PRODUCT BULLETIN # 16629

TITLE: Packaging change for 7" Reels

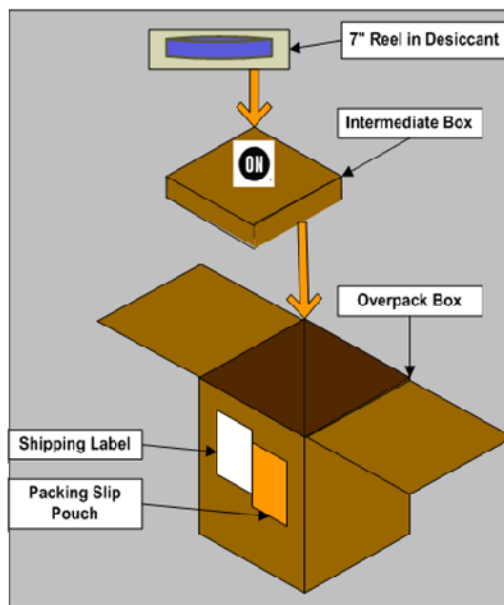
Current: 7" reels placed in desiccant bag in individual intermediate box.

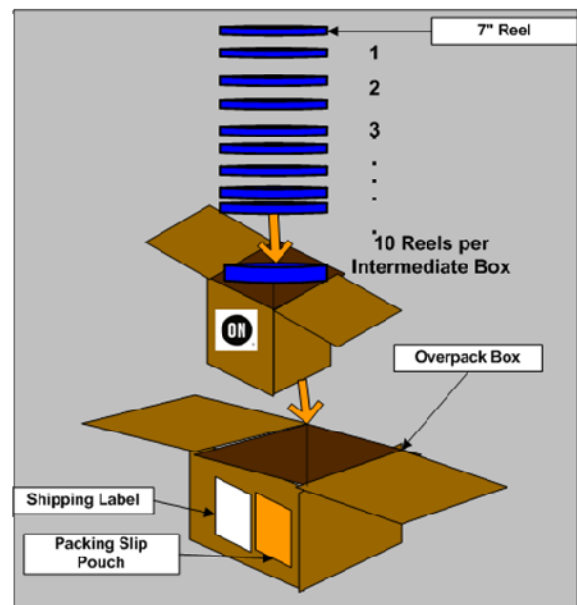
To be: 7" reels placed 10 per Intermediate box, no desiccant bag.
